DEVELOPMENT REVIEW BOARD REPORT

Storage at McDowell 46-DR-2019	Request by owner for approval of a site plan, landscape plan, and building elevations for a new storage facility development on a +/- 1.36 -acre site with Highway Commercial (C-3) zoning, located at 7025 E. McDowell Rd.
---	---

PHOTOMETRIC SITE PLAN

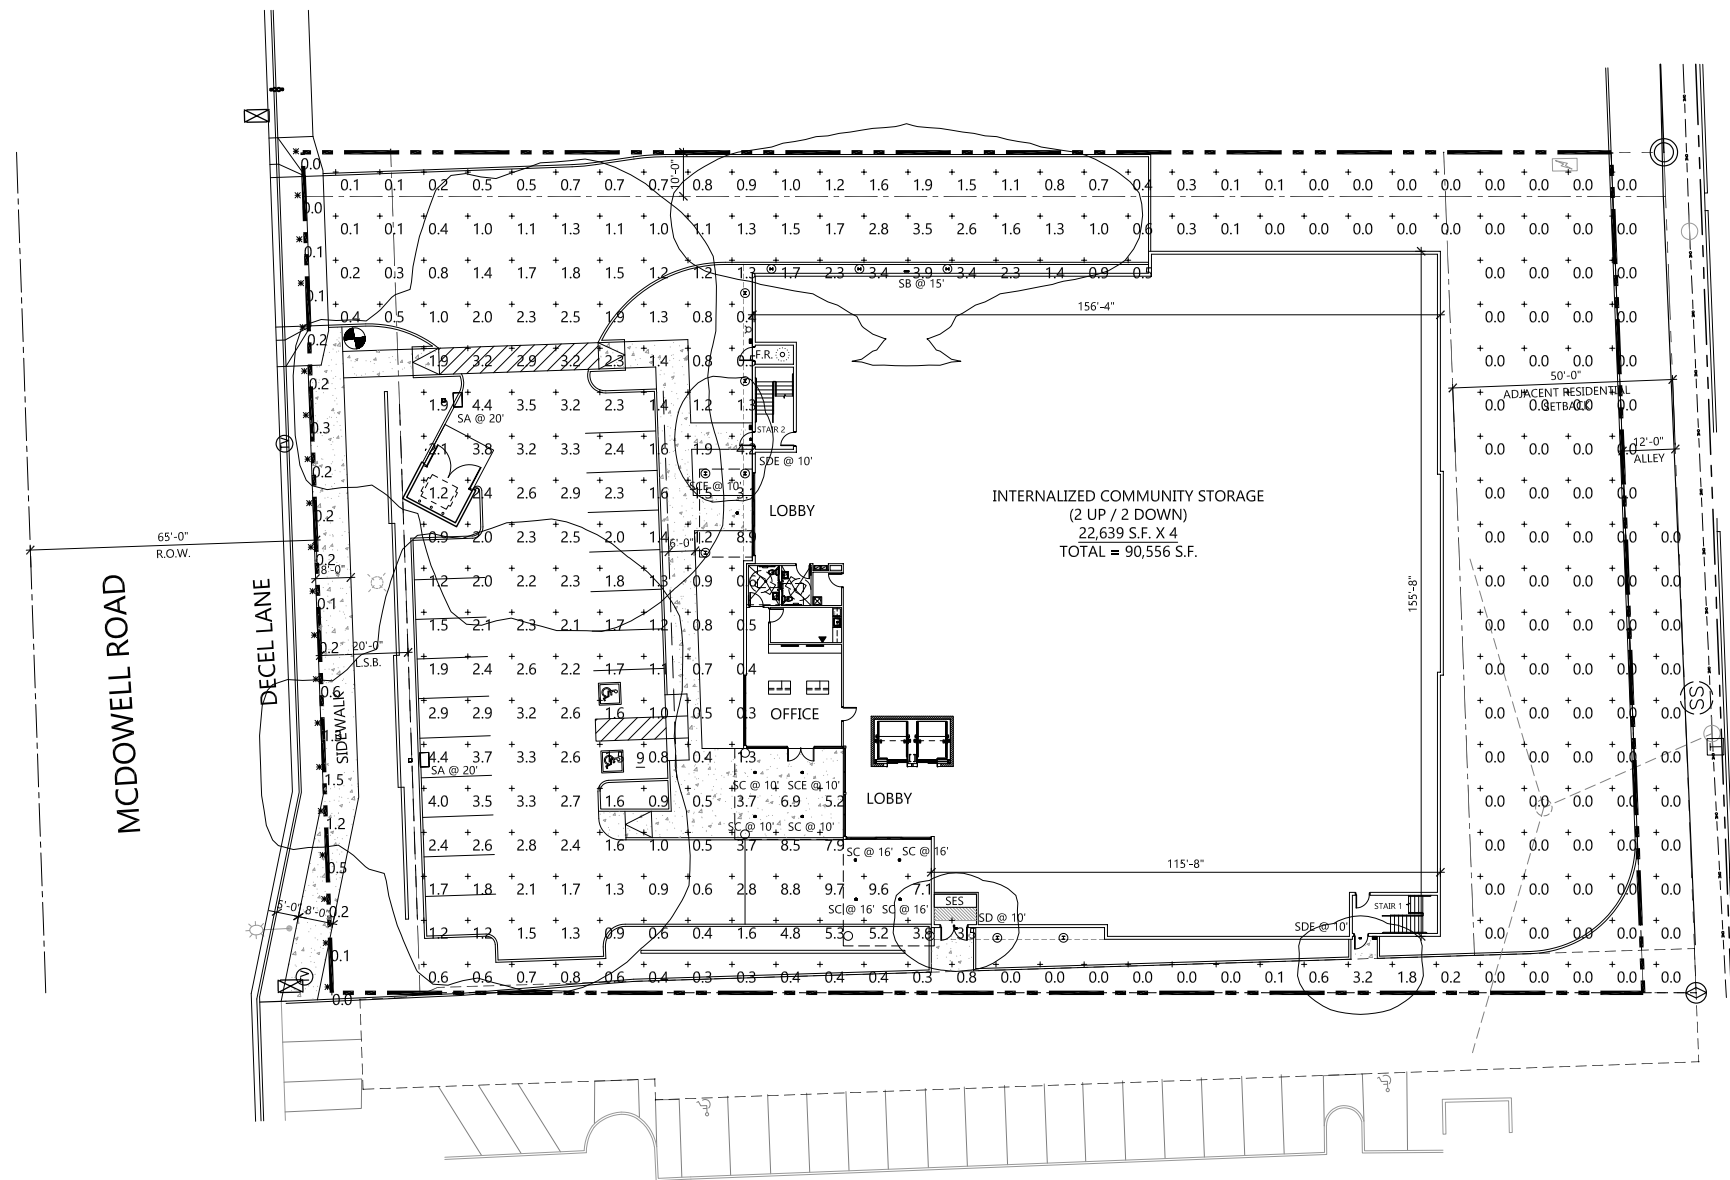
- 14. With final plans, the lighting sheets shall be updated to include bollard lighting within the landscape area adjacent to the southern property line for consistency with Papago Plaza alley improvements which include new lighting. Bollards shall be directed downward and shielded.

- c. The initial vertical luminance at 6-foot above grade, along the southern entire property line shall not exceed 3.0 foot-candles to provide sensitivity to the southern residential neighbors. All exterior luminaires shall be included in this calculation.
